Millstone Nuclear Power Station Northeast Nuclear Energy Company P.O. Box 128 Waterford, CT 06385-0128 (860) 447-1791 Fax (860) 444-4277

Docket No. 50-336 B17682

Millstone Nuclear Power Station, Unit No. 2
Response to Request For Additional Information Concerning
Leak Before Break Evaluation of the Pressurizer Surge Piping

Figure 1. Maximum Pressurizer Temperature as a Function of RCS Temperature (Extracted from SIR-99-021, Rev. 0)

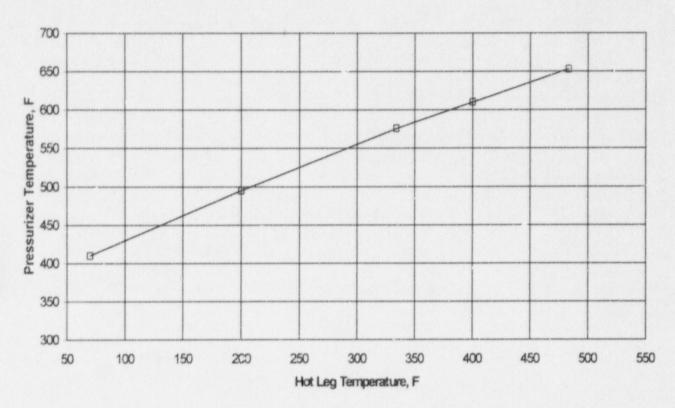
The six different stratification load case evaluations discussed above are based on the expected magnitude of thermal stratification from operating procedures and actual plant records. NNECO believes that the conditions evaluated are sufficient to show the applicability of LBB for all stratification conditions. The result of these evaluations are plotted in Figure 1 and show the maximum pressurizer temperature as a function of the RCS hot leg temperature which would meet the LBB acceptance criteria.

In actual practice, however, during startup, increasing pressure and stratification ΔT will lead to significant leakage from a LSC (i.e., a flaw that leaks at 10 gpm for normal operating conditions with a stratification $\Delta T = 49^{\circ} F$). Significant leakage will lead to a cooldown of the plant, such that decreasing pressure and ΔT will reduce the stresses in the piping prior to reaching the higher pressure/temperature conditions later in a heatup. On the other hand, detection of leakage during normal operation requires that all potential conditions associated with cooldown must be passed through. The evaluated conditions adequately bound all expected thermal stratification magnitudes and associated RCS pressures and temperatures.

In order to minimize/eliminate those plant conditions which could result in ΔTs in excess of those provided in Figure 1, NNECO will incorporate the information from Figure 1 into the appropriate plant procedures.
